2018 Mercedes Benz E63S AMG 4MATIC Sed (213.089) V8-4.0L Turbo (177.980)

UPDATE ENGINE ELECTRONICS (ME-SFI) CONTROL UNIT SOFTWARE

Service Campaign Bulletin

Campaign No. 2019060011, January 2020

Figure 1

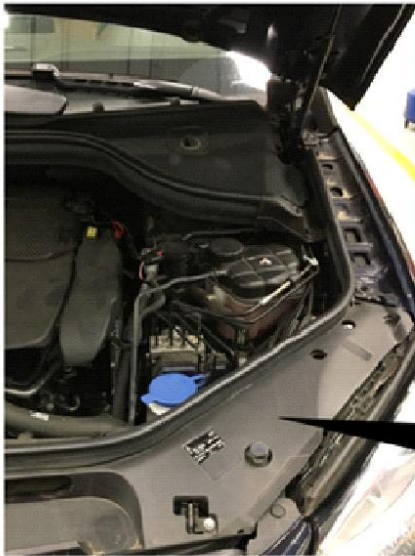
Apply Proof of Correction Label (A 000 584 54 13) to area identified in **Figure 1**. Fill in Campaign P-SC-2019060011, your dealer code, and the date of the repair, using a black permanent marker.

i Note: Clean bonding surface prior to affixing label.
